Mamre Road upgrade between the M4 Motorway and Erskine Park Road

Addendum review of environmental
factors
April 2024

This document is an addendum Review of Environmental Factors (Addendum REF) for a proposed modification to the approved 'Mamre Road upgrade between the M4 Motorway and Erskine Park Road' project (the approved project).

C:\Users\QI.Shen\Aurecon Group\509458 - No Contract\Mamre Road Stage 1 - 904 GIS\New Folder Structure\Pro\Figures\509458_TheProposedModification\TheProposedModification_20230822.aprx\JOB No.118-08-23\QI_Shen\Rev 0

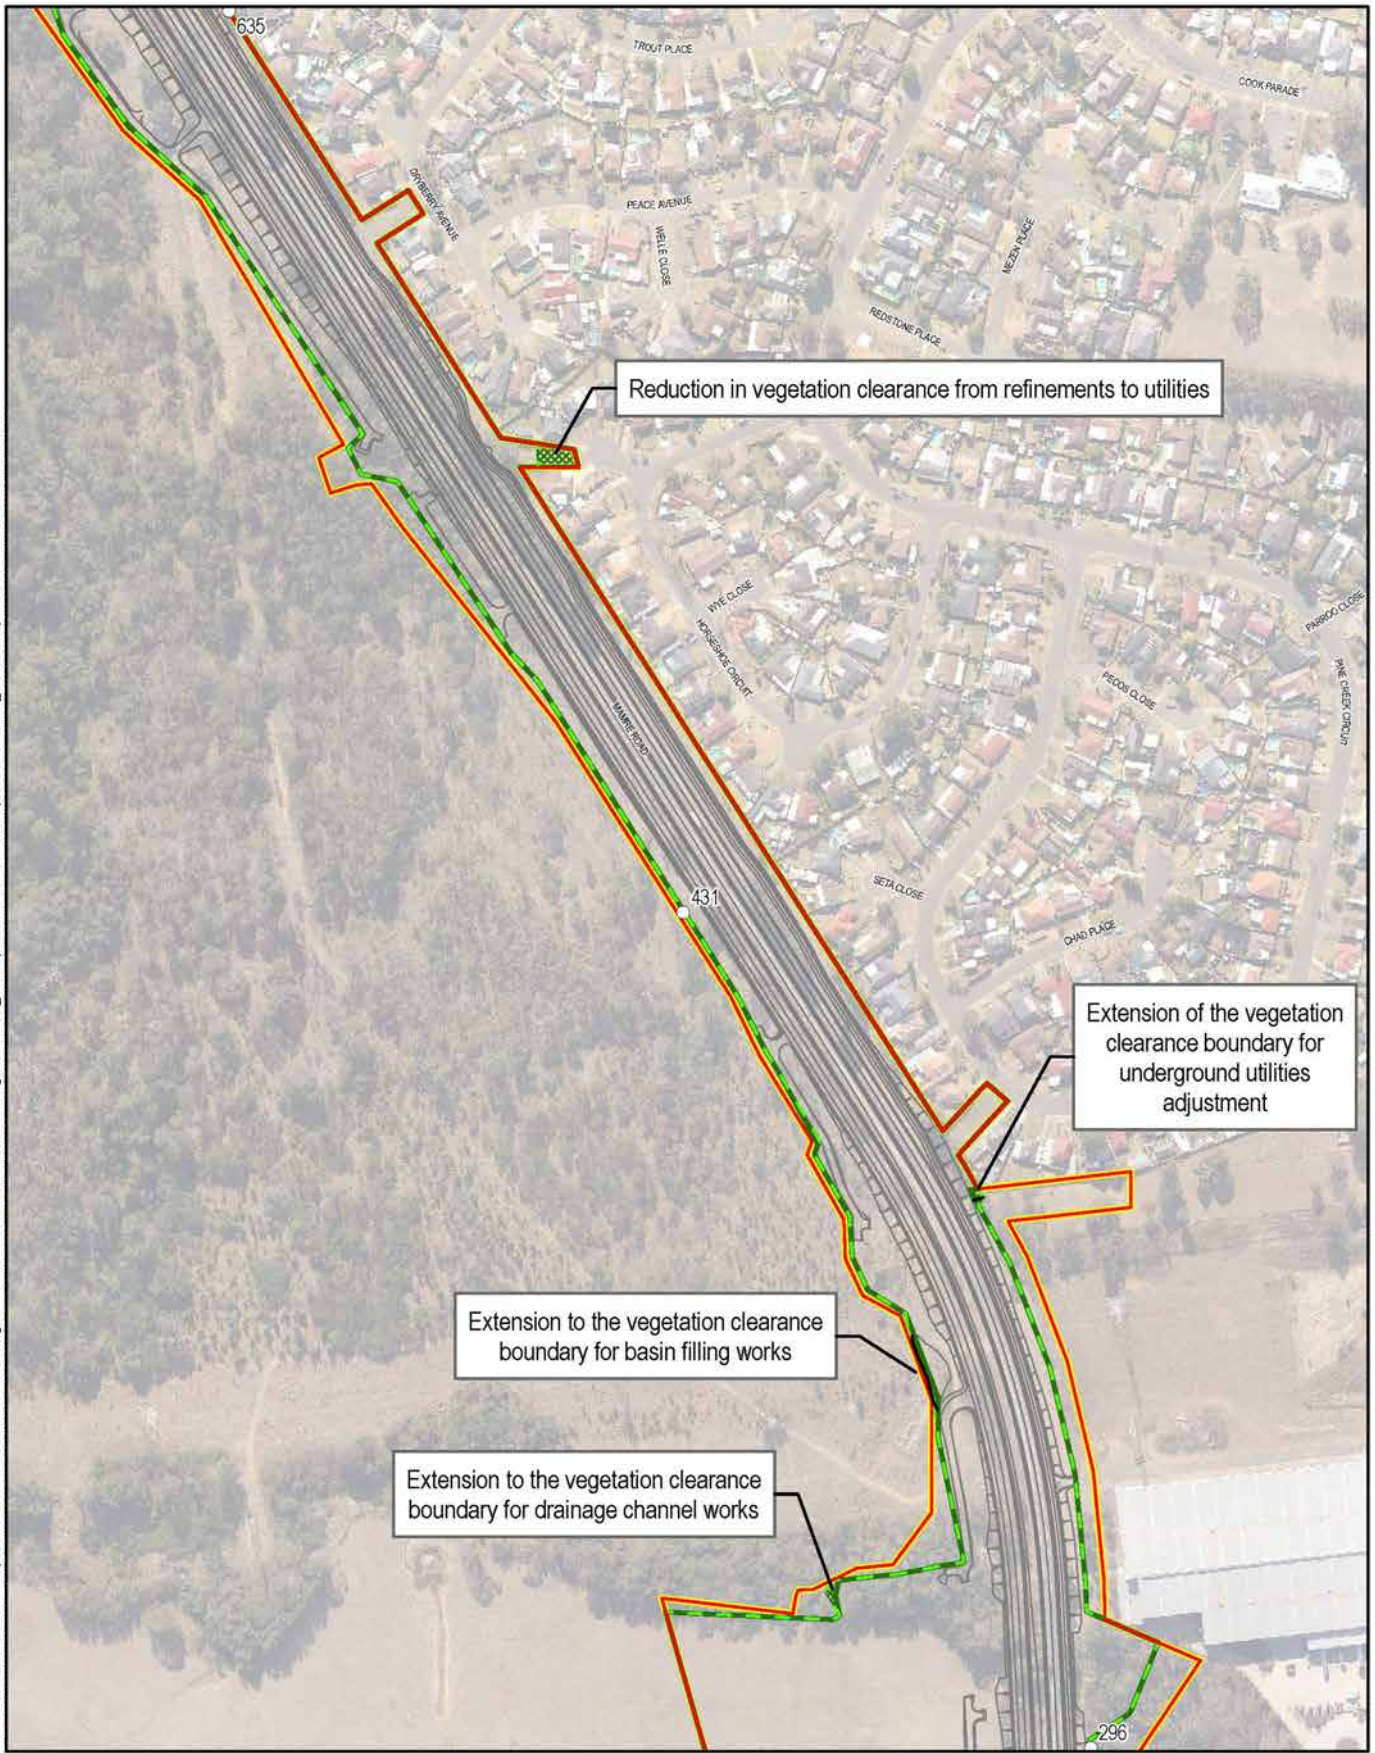
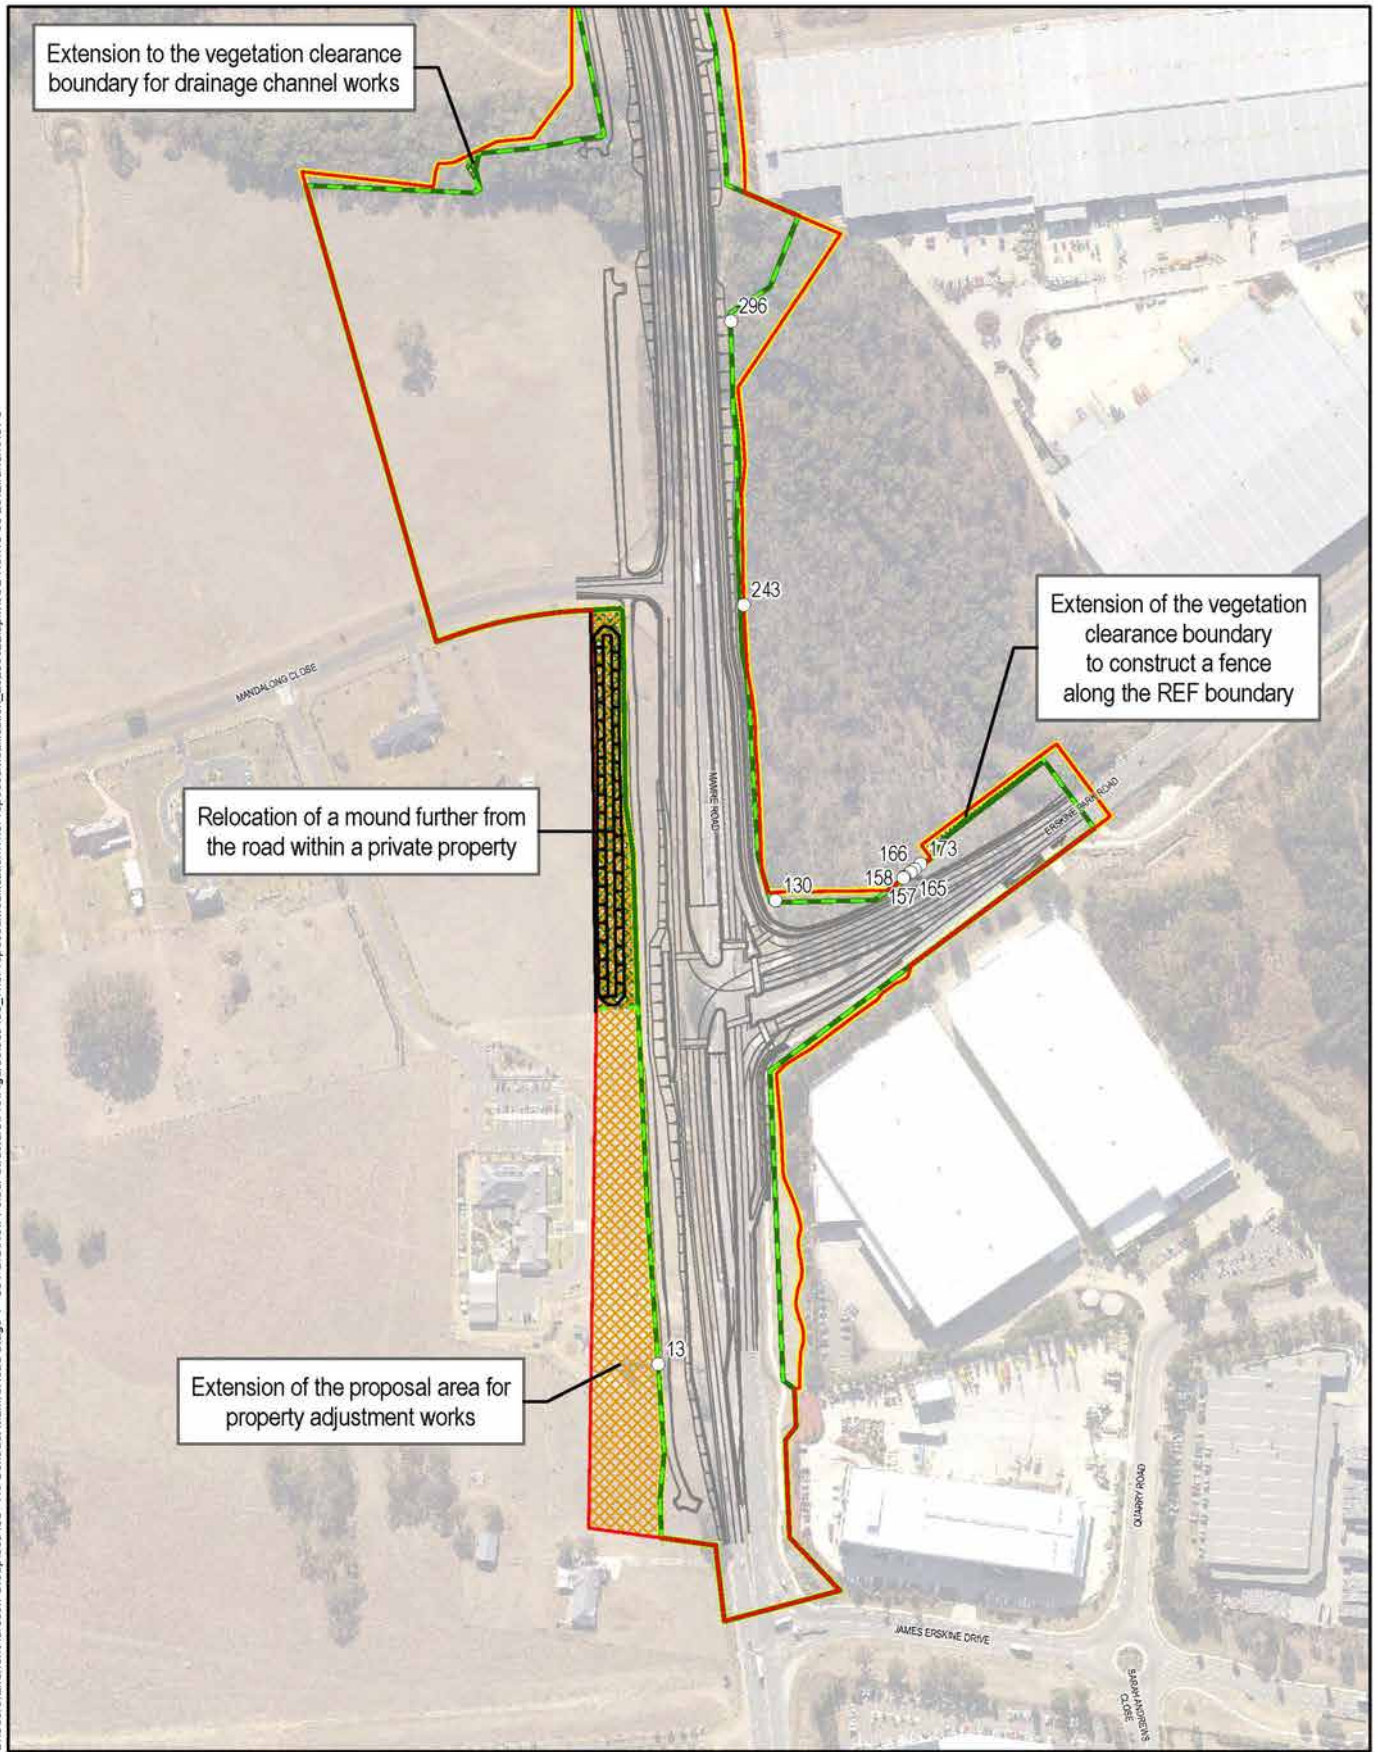
Transport now proposes to modify the approved project to facilitate adjustments to utilities, minor property work and other minor work to support the upgrade of Mamre Road (referred to as the proposed modification). Key features of the proposed modification include:

- basin filling work and refinements to drainage channels
- property work including the relocation of parking areas at Erskine Park Rural Fire Service, adjustment to the driveway at the KFC fast food restaurant, and relocation of an existing earth mound within private property

- removal of additional trees identified by an arborist to have likely root impacts from the road upgrade work (see Figure 1-2)
- extension of the shared path between Banks Drive and the M4 Motorway

- relocation of the heritage node near Mamre House
- provision of additional space to enable fence construction (see Figure 1-2)
- construction of a turning tee to connect to an existing access track located on the western side of Mamre Road (see Figure 1-2)

- relocation of existing signage near the northern extent of the approved proposal area to an existing post
- utilities that may require additional excavation outside of the approved proposal area.
